1570-1580 CANTERBURY RD, PUNCHBOWL NSW 2196
LOT 54 / DP12280 & LOT 2 DP589284

MIXED-USE DEVELOPMENT ACROSS THREE TOWERS (PART CLASS 2 & PART CLASS 5) WITH SHARED BASEMENT PARKING (CLASS 7A)

MODIFICATION APPLICATION UNDER S.455(2) OF THE EP&A ACT

TOTAL OF 58 RESIDENTIAL APARTMENTS AND 2 GROUND FLOOR COMMERCIAL TENANCIES,
WITH BASEMENT CARPARKING FOR 88 VEHICLES ACCESSED VIA
RIGHT OF WAY OVER 17 WEYLAND STREET

DRAWING NO.
A0001

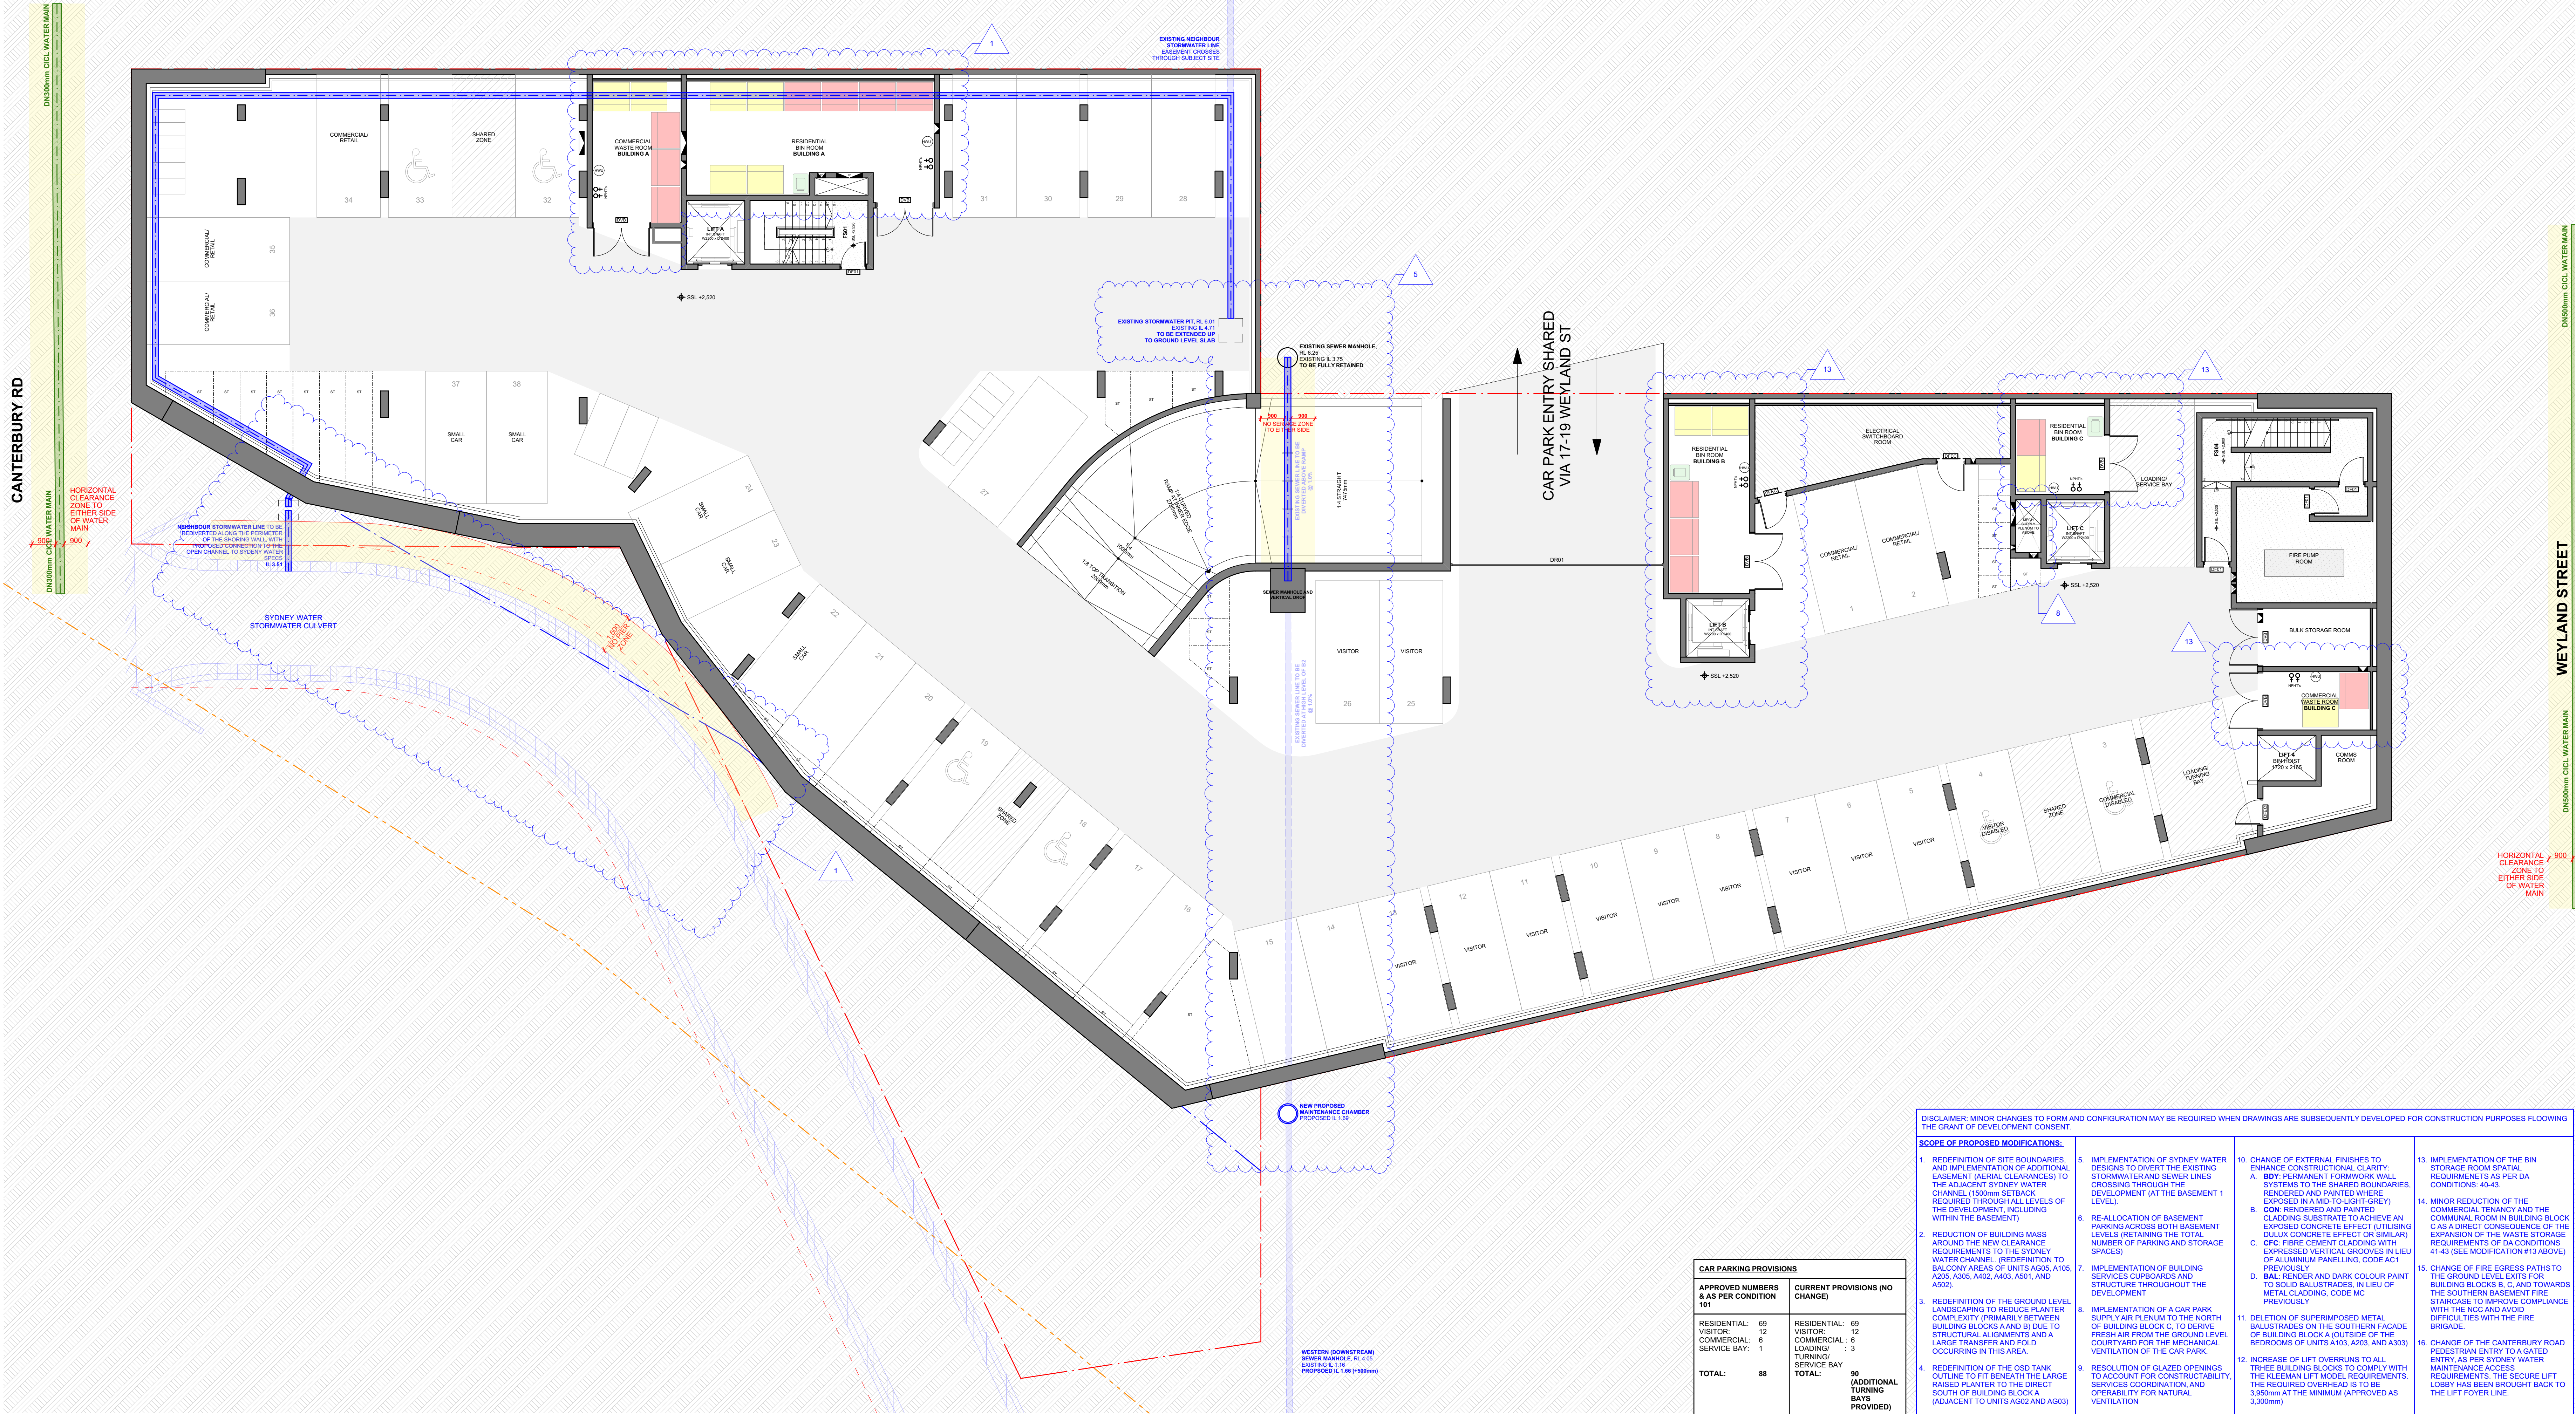
- SCOPE OF PROPOSED MODIFICATIONS:**
- REDEFINITION OF SITE BOUNDARIES, AND IMPLEMENTATION OF ADDITIONAL EASEMENT (AERIAL CLEARANCES) TO THE ADJACENT SYDNEY WATER CHANNEL, 150mm SETBACK REQUIRED THROUGH ALL LEVELS OF THE DEVELOPMENT, INCLUDING WITHIN THE BASEMENT.

- REDEFINITION OF THE GROUND LEVEL LANDSCAPING TO REDUCE PLANTER COMPLEXITY PRIMARILY BETWEEN BUILDING BLOCKS A AND B) DUE TO STRUCTURAL ALIGNMENTS AND A LARGE TRANSFER AND FOLD OCCURRING IN THIS AREA.

- REDEFINITION OF THE OSD TANK OUTLINE TO FIT BENEATH THE LARGE RAISED PLANTER TO THE DIRECT SOUTH OF BUILDING BLOCK A (ADJACENT TO UNITS A202 AND AG03)

- CHANGE OF EXTERNAL FINISHES TO ENHANCE CONSTRUCTIONAL CLARITY:
A. BOY PERMANENT FORMWORK WALL SYSTEMS TO THE SHARED BOUNDARIES, RENDERED AND PAINTED WHERE EXPOSED IN A MID-TO-LIGHT-GREY.

- MINOR REDUCTION OF THE COMMERCIAL TENANCY AND THE COMMUNAL ROOM IN BUILDING BLOCK C AS A DIRECT CONSEQUENCE OF THE EXPANSION OF THE WASTE STORAGE REQUIREMENTS OF DA CONDITIONS 41-43 (SEE MODIFICATION #13 ABOVE)

- CHANGE OF FIRE EGRESS PATHS TO THE GROUND LEVEL EXITS FOR BUILDING BLOCKS B, C, AND TOWARDS THE SOUTHERN BASEMENT FIRE STAIRCASE TO IMPROVE COMPLIANCE WITH THE NCC AND AVOID DIFFICULTIES WITH THE FIRE BRIGADE.

- CHANGE OF THE CANTERBURY ROAD PEDESTRIAN ENTRY TO A GATED ENTRY AS PER SYDNEY WATER MAINTENANCE ACCESS REQUIREMENTS. THE SECURE LIFT LOBBY HAS BEEN BROUGHT BACK TO THE LIFT FOYER LINE.

REVISION NO.
A
DRAWING NO.
A0102

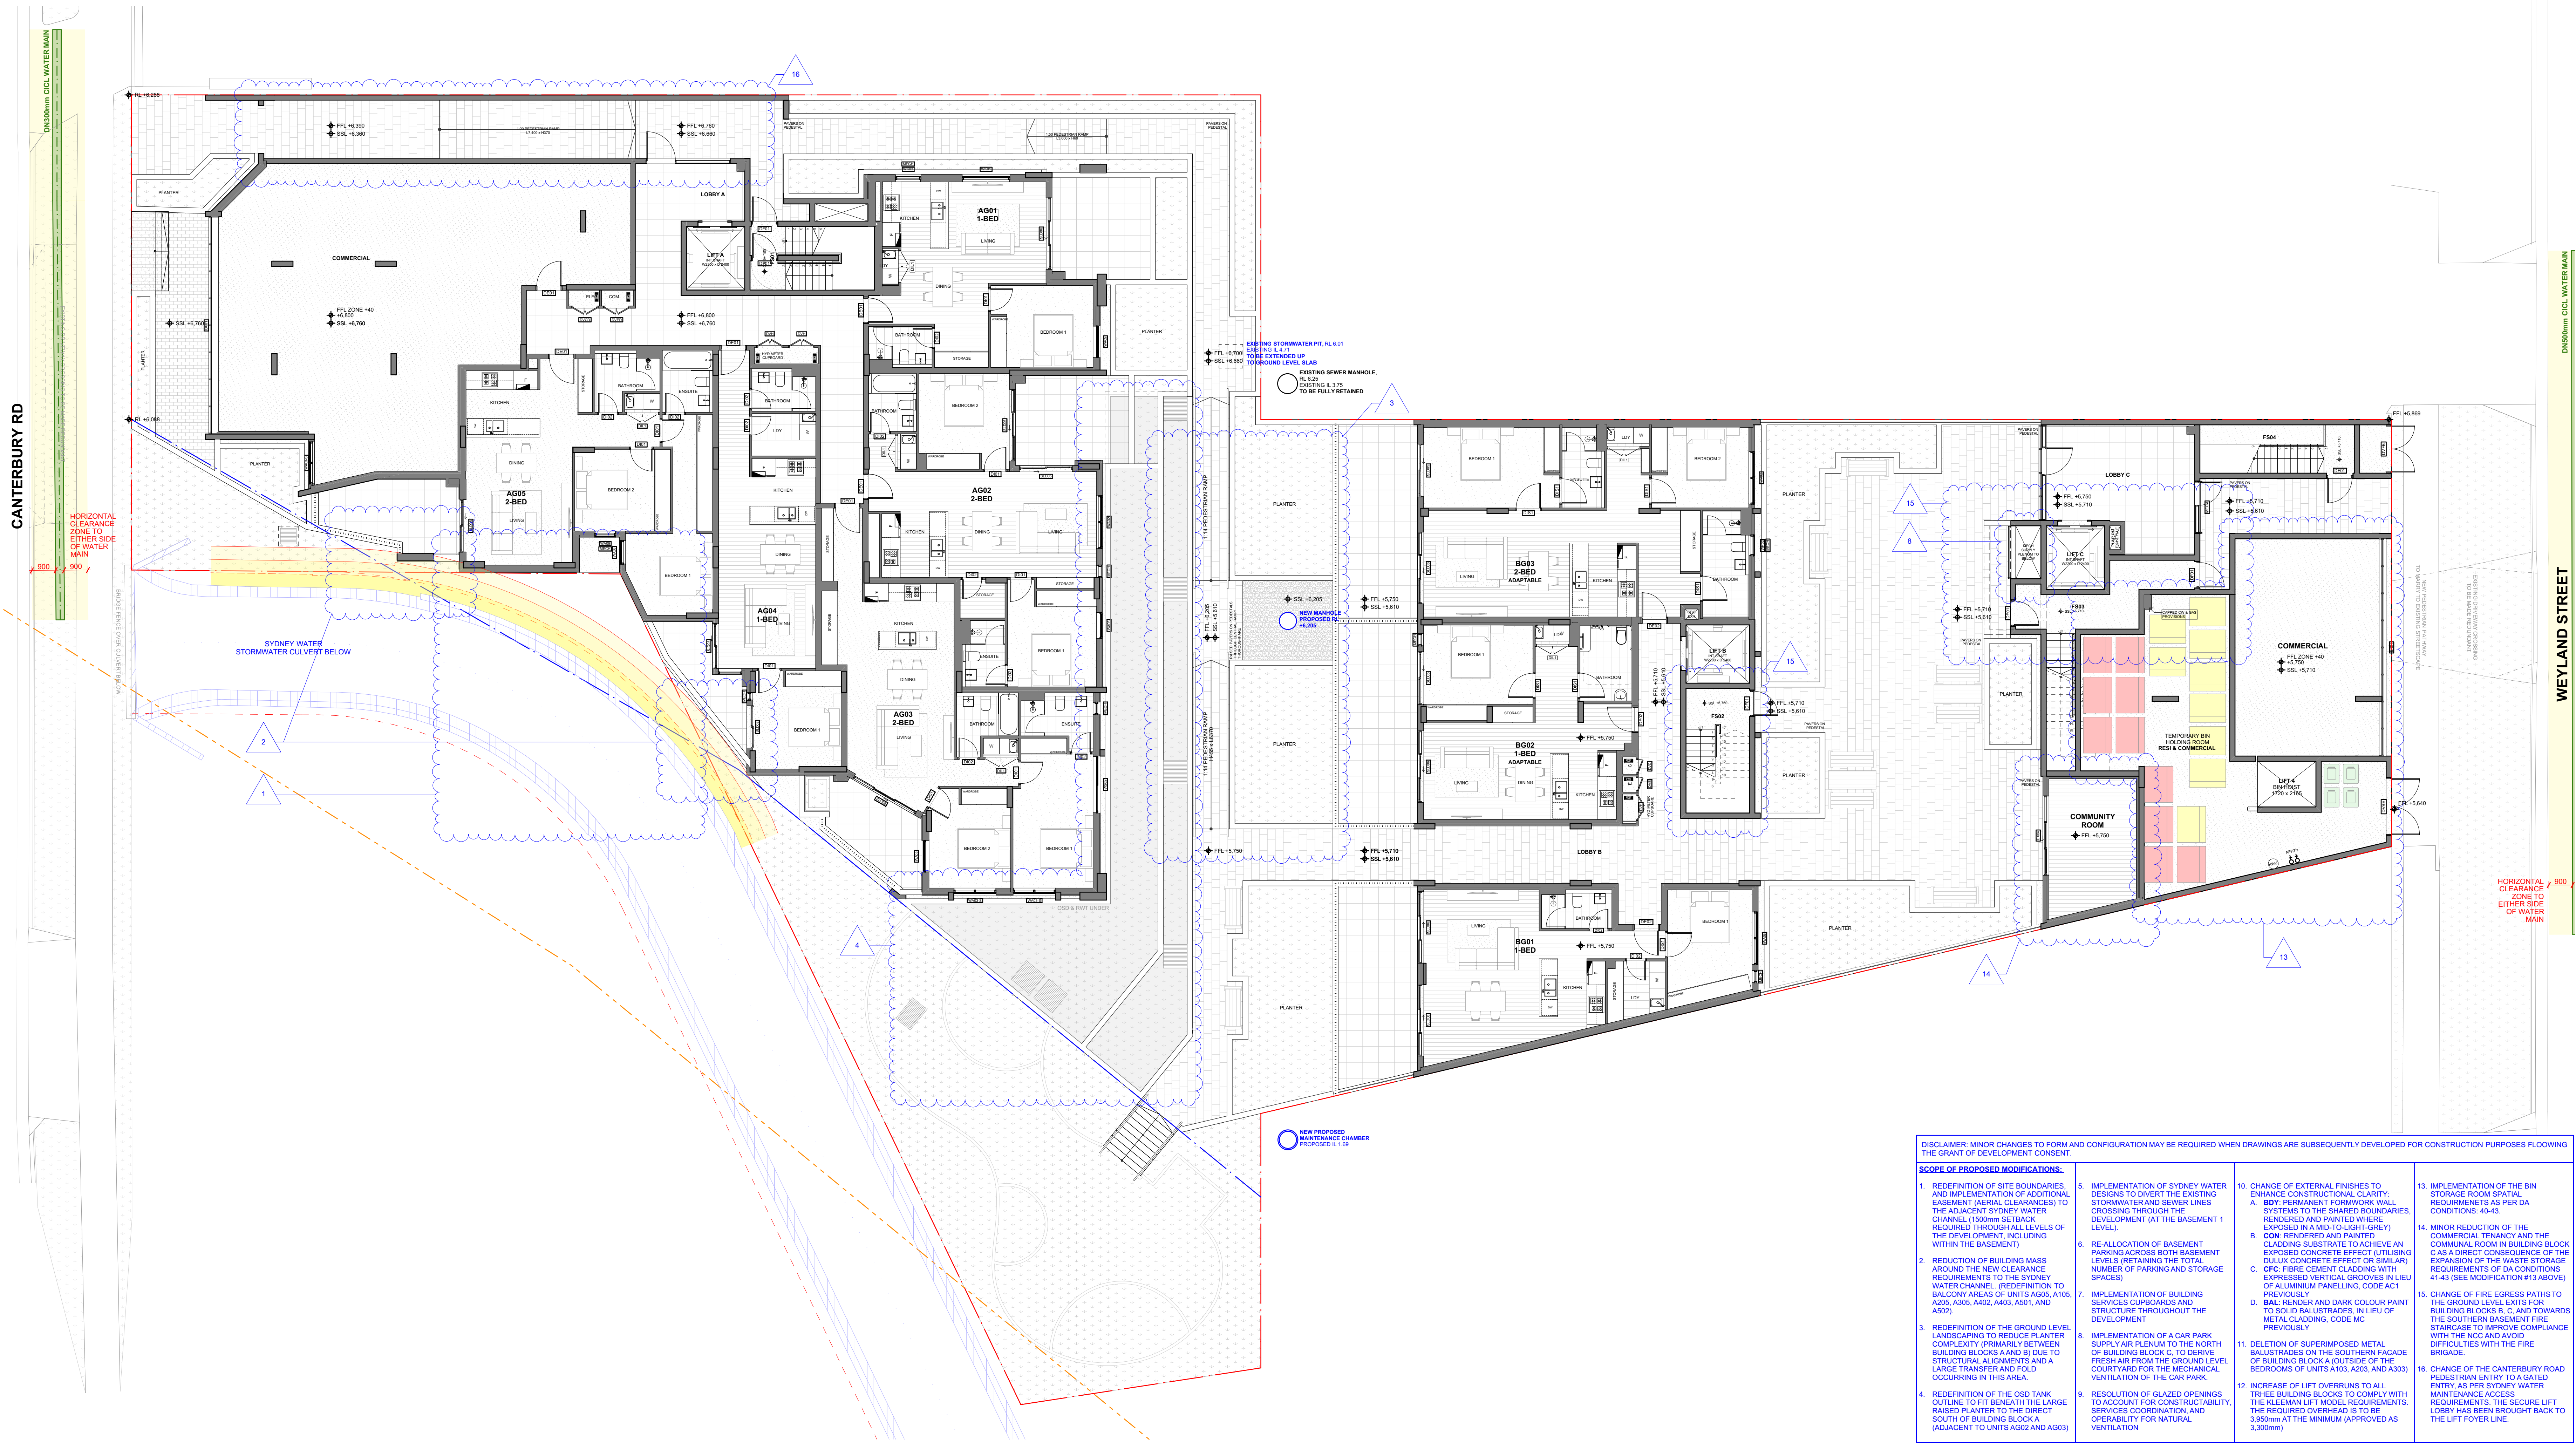
SCOPE OF PROPOSED MODIFICATIONS: 1. REDEFINITION OF SITE BOUNDARIES, AND IMPLEMENTATION OF ADDITIONAL EASEMENT (AERIAL CLEARANCES) TO THE ADJACENT SYDNEY WATER CHANNEL (150mm SETBACK) REQUIRED THROUGHOUT ALL LEVELS OF THE DEVELOPMENT, INCLUDING WITHIN THE BASEMENT. 2. REDUCTION OF BUILDING MASS AROUND THE NEW CLEARANCE REQUIREMENTS TO THE SYDNEY WATER CHANNEL. REDEFINITION TO BALCONY AREAS OF UNITS AG05, A105, A205, A305, A402, A403, A501, AND A502. 3. REDEFINITION OF THE GROUND LEVEL LANDSCAPING TO REDUCE PLANTER COMPLEXITY PRIMARILY BETWEEN BUILDING BLOCKS A AND B) DUE TO STRUCTURAL ALIGNMENTS AND A LARGE TRANSFER AND FOLD OCCURRING IN THIS AREA. 4. REDEFINITION OF THE OSD TANK OUTLINE TO FIT BENEATH THE LARGE RAISED PLANTER TO THE DIRECT SOUTH OF BUILDING BLOCK A (ADJACENT TO UNITS AG02 AND AG03).	5. IMPLEMENTATION OF SYDNEY WATER DESIGNS TO DIVERT THE EXISTING STORMWATER AND SEWER LINES CROSSING THROUGH THE DEVELOPMENT (AT THE BASEMENT 1 LEVEL). 6. RE-ALLOCATION OF BASEMENT PARKING ACROSS BOTH BASEMENT LEVELS (RETAINING THE TOTAL NUMBER OF PARKING AND STORAGE SPACES) 7. IMPLEMENTATION OF BUILDING SERVICES CURPORDARDS AND STRUCTURE THROUGHOUT THE DEVELOPMENT 8. IMPLEMENTATION OF A CAR PARK SUPPLY AIR PLENUM TO THE NORTH OF BUILDING BLOCK C, TO DERIVE FRESH AIR FROM THE GROUND LEVEL BEDROOMS OF UNITS A103, A203, AND A303) 9. RESOLUTION OF THE OSD TANK OUTLINE TO FIT BENEATH THE LARGE RAISED PLANTER TO THE DIRECT SOUTH OF BUILDING BLOCK A (ADJACENT TO UNITS AG02 AND AG03).	10. CHANGE OF EXTERNAL FINISHES TO ENHANCE CONSTRUCTIONAL CLARITY: A. BOY PERMANENT FORMWORK WASTE SYSTEMS TO THE SHARED BOUNDARIES. B. CON: RENDERED AND PAINTED CLADDING SUBSTRATE TO ACHIEVE AN EXPOSED CONCRETE EFFECT (UTILISING DULUX CONCRETE EFFECT OR SIMILAR) C. CPC: FIBRE CEMENT CLADDING WITH EXPRESSED VERTICAL GROOVES IN LIEU OF ALUMINIUM PANELING, CODE AC1 PREVIOUSLY D. BAL: RENDER AND DARK COLOUR PAINT TO SOLID BALUSTRADES, IN LIEU OF METAL CLADDING, CODE MC PREVIOUSLY 11. DELETION OF SUPERIMPOSED METAL BALUSTRADES ON THE SOUTHERN FACADE OF BUILDING BLOCK A (OUTSIDE OF THE BEDROOMS OF UNITS A103, A203, AND A303) 12. INCREASE OF LIFT OVERRUNS TO ALL THREE BUILDING BLOCKS TO COMPLY WITH THE KLEEMAN LIFT MODEL REQUIREMENTS. THE REQUIRED OVERHEAD IS TO BE 3.500mm AT THE MINIMUM (APPROVED AS 3.500mm)	13. IMPLEMENTATION OF THE BIN STORAGE ROOM SPATIAL REQUIREMENTS AS PER DA CONDITIONS: 40-43. 14. MINOR REDUCTION OF THE COMMERCIAL TENANCY AND THE COMMUNAL ROOM IN BUILDING BLOCK C AS A DIRECT CONSEQUENCE OF THE EXPANSION OF THE WASTE STORAGE REQUIREMENTS OF DA CONDITIONS 41-43 (SEE MODIFICATION #13 ABOVE) 15. CHANGE OF FIRE EGRESS PATHS TO THE GROUND LEVEL EXITS FOR BUILDING BLOCKS B, C, AND TOWARDS THE SOUTHERN BASEMENT FIRE STAIRCASE TO IMPROVE COMPLIANCE WITH THE NCC AND AVOID DIFFICULTIES WITH THE FIRE BRIGADE. 16. CHANGE OF THE CANTERBURY ROAD PEDESTRIAN ENTRY TO A GATED ENTRY AS PER SYDNEY WATER MAINTENANCE ACCESS REQUIREMENTS. THE SECURE LIFT LOBBY HAS BEEN BROUGHT BACK TO THE LIFT FOYER LINE.
